**Flood Control Project Maintenance
Levee Inspections**
LMA District Cover Sheet
Spring 2018 Levee Inspection Results

Reclamation District No. 0765 Glide

Levee Inspection Report By Mile - Spring 2018

Waterway	Bank	Unit Miles	Inspection Start/End	Inspector
Unit No. 01 Sacramento River	Right	1.72	03/07/2018 03/07/2018	Dave Torres

Photo 2 of 2 : SP_2018_RD0765_211_14_20180301_00020.jpg

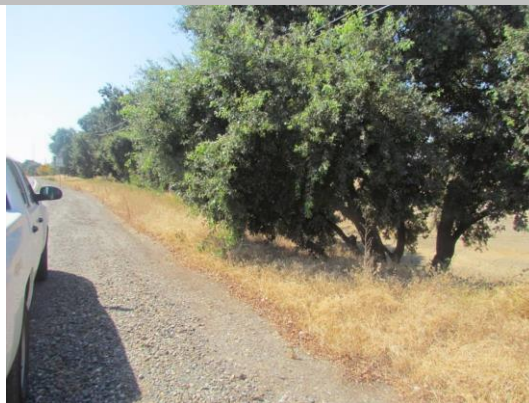
LM Start	0.27	Rating **	M	Issue No.	14 (cont)	
LM End	0.30	Issue Type +	Ma	Location *	LS	
Category	Earthen Levee			GPS Latitude/Longitude		
				Start		End
Item	Trim / Thin Trees			38.499065 °		38.498714 °
				-121.560468 °		-121.560460 °
DWR ID	DWR_RD0765_01_s_2012_14					
Comment Code						
T1 : Trim trees to at least five feet above ground level.						
Inspector Comment						
Untrimmed trees on landside slope has been untrimmed for multiple inspection cycles.

Photo 1 of 1 : SP_2018_RD0765_211_1_20180301_00001.jpg

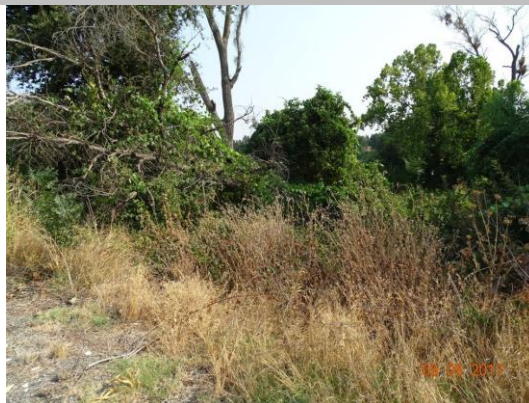
LM Start	1.58	Rating **	U	Issue No.	1
LM End	1.58	Issue Type +	Ma	Location *	WS
Category	Earthen Levee			GPS Latitude/Longitude	
				Start	End
Item	Encroachments			38.481959 °	38.481959 °
				-121.550527 °	-121.550527 °
DWR ID	DWR_RD0765_01_f_2017_1				
Comment Code					
TR : Tree or limb					
Inspector Comment					
Downed tree on waterside slope.
